February 19, 2008

RE: Questions regarding Carrizo Energy Solar Farm
Docket# 07-AFC-08

Attachment 1b

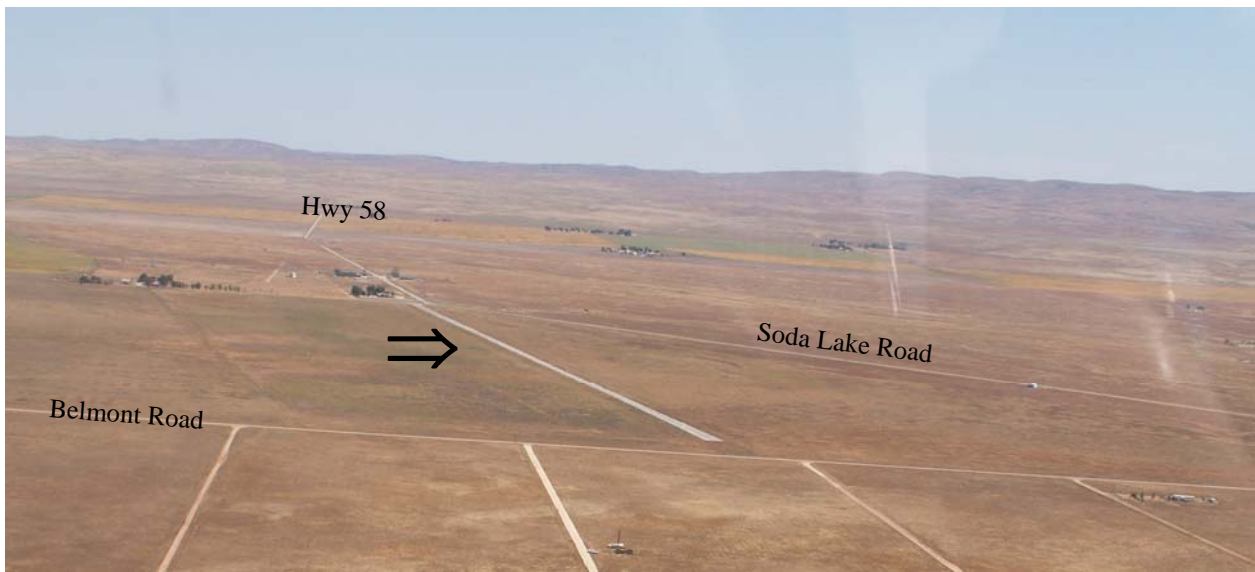
This Airstrip is in fact **4,200 feet long and PAVED!** (*attachment 1b*). (*check with the FAA for airstrip number, as we are a certified strip) and within the 20,000 foot mark from the proposed project site. The Airstrip is owned by John Ruskovich, is used privately and as a landing site for CHP, BML, CalFire, and emergency medical Helicopter evacuation. This strip has the capacity to land a Super-King aircraft, which it has on numerous occasions, bringing in government officials to the National Monument.

We request, as stated in your regulations, that a Federal Aviation report be completed because of the potential thermal plumes and water vapor plumes. Also, that the length and type of strip be corrected in the proposal.
